Fingerboards Mineral Sand Project

Inquiry and Advisory Committee (IAC) Panel Hearing

Groundwater

Assoc Prof John Webb

Georgiou IAC presentation slide 25

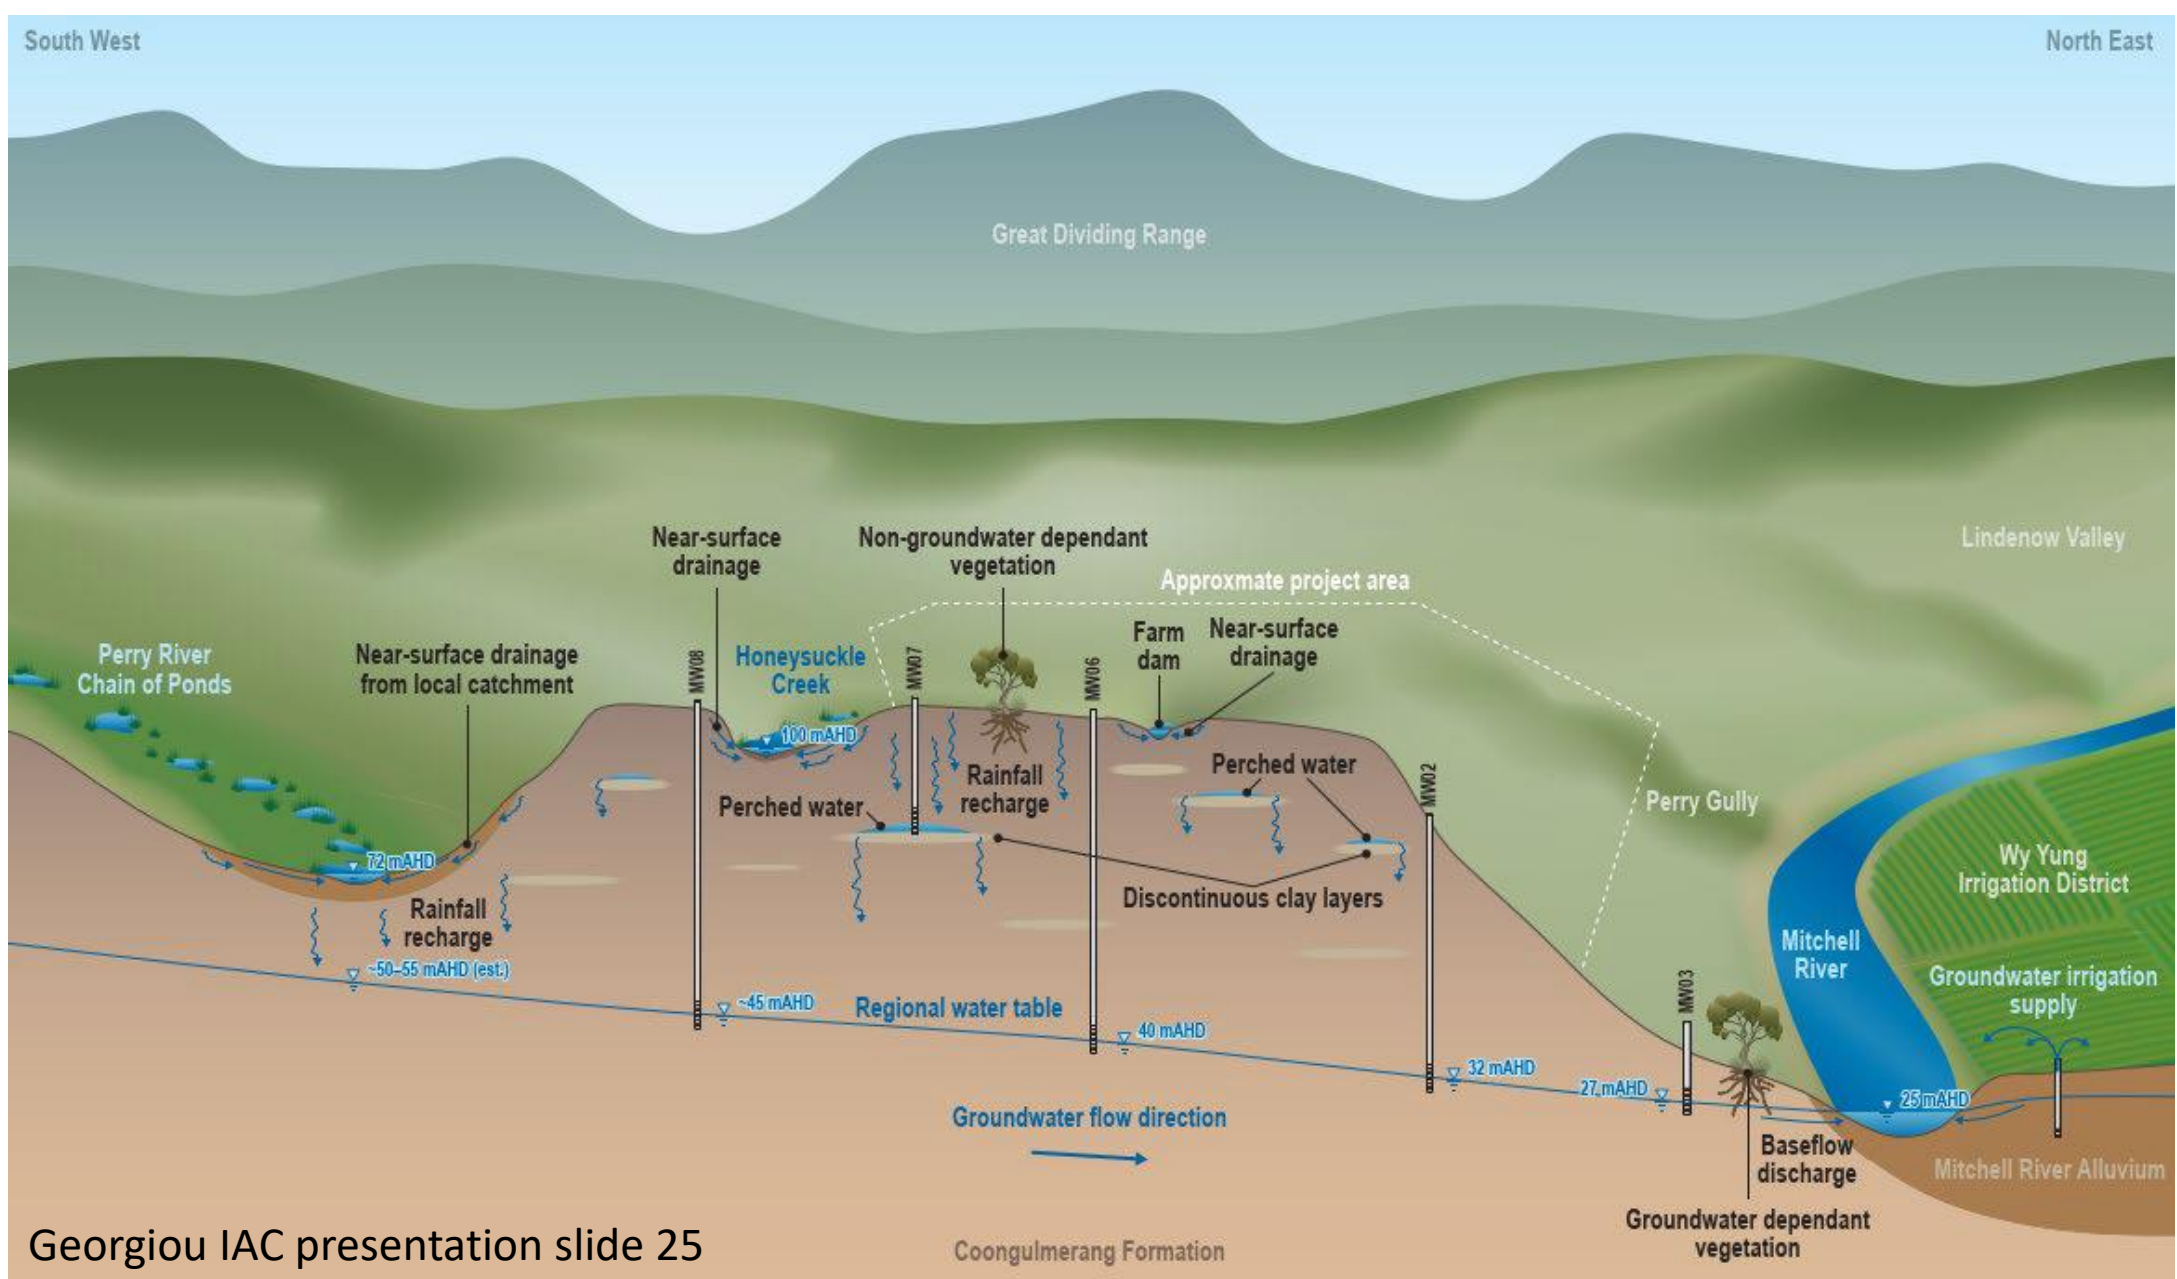
However, areas of perched groundwater could have retained their pyrite content if they have remained saturated

- Therefore Acid Sulphate Soils may exist at the site. The desktop study found that the presence of ASS at the Fingerboards mine site was unlikely but did not consider the influence of perched water tables.

- If water-saturated sediment is encountered at perched water tables during mining, the sediment must be analysed for Cr-reducible sulphur.
- If Cr-reducible sulphur levels in this sediment are $>0.03\%$, the sediment is classified as an Acid Sulphate Soil and will require a management plan to comply with EPA ASS Guidelines, in order to prevent the release of acidity into the environment.

Fig 3 A001

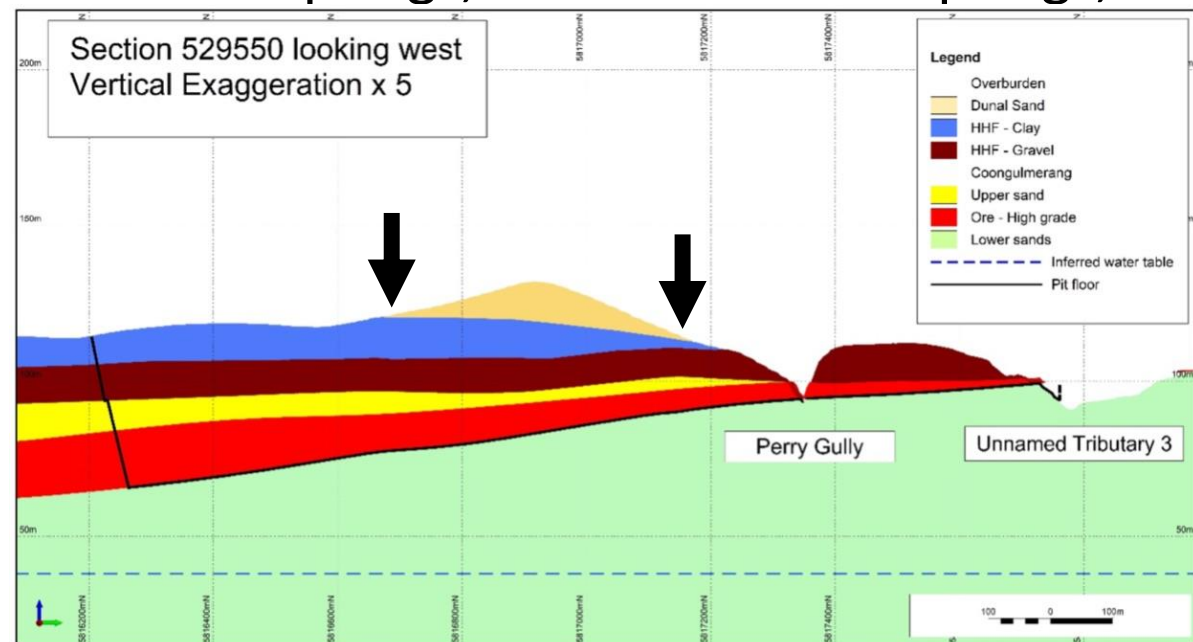
- According to landholders, there are a number of spring-fed dams around the proposed mine site. In addition, parts of Moulin/Stoney Creek apparently never dry out and may be spring fed.
- It is likely that at least some of these springs emerge at the boundary between the Pleistocene dune sand and the underlying, less permeable Haunted Hills Formation
- If this is the case, any mine works that remove the dune sand or interfere with the flow paths within the sand towards the springs, could cause the springs, and therefore the dams, to dry up.
